SCOPE OF WORK
Installation of CCAC Walkway Fence
September 2015
EMBASSY DJIBOUTI

1 PROJECT DESCRIPTION

U.S. Department of State Office of Overseas Buildings Operations	ANTI - CLIMB FENCE DESIGN AC-41-04 (TUBES 150mm OC)	DWG. TITLE: AC-41-04.dwg	
	OBO/SEB Security Details	REV: _____ DATE: _____ REV: _____ DATE: _____ SCALE: 1:20 SHEET: 2 OF 7 DRAWN BY: JG DATE: January 2009 UNCLASSIFIED

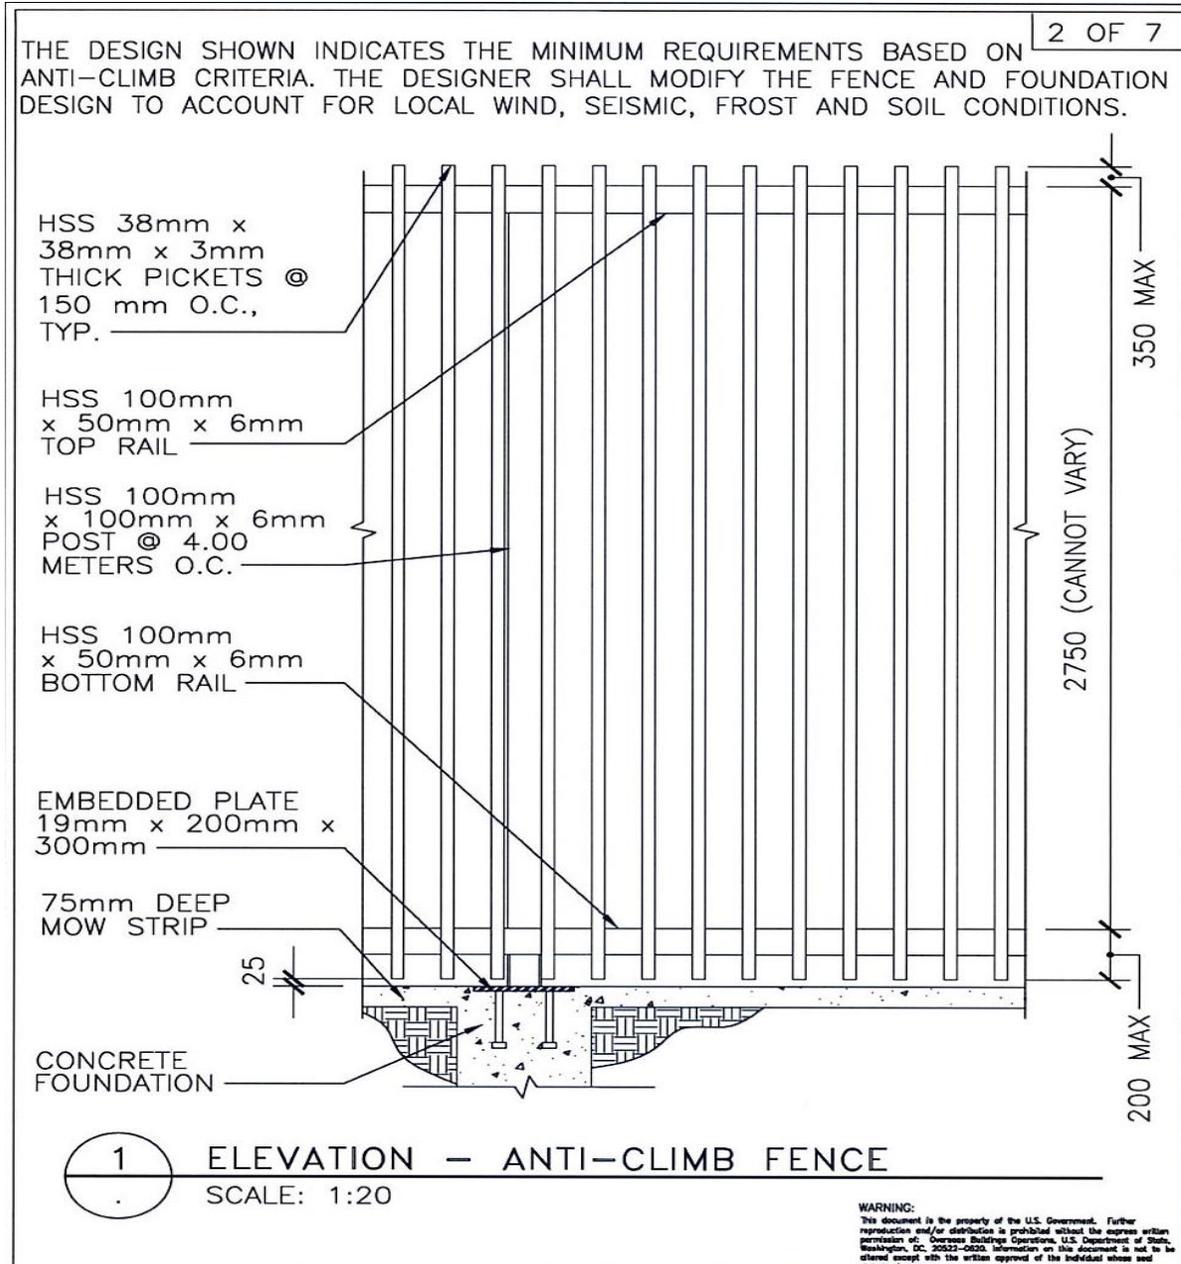
2.3.2.1 The support post height will be 1420mm from grade vice the 3300mm shown on the drawings.

2.3.2.2 The height of the fence will be 1380mm from the top surface of the bottom horizontal support vice the 2750mm noted on the drawings.
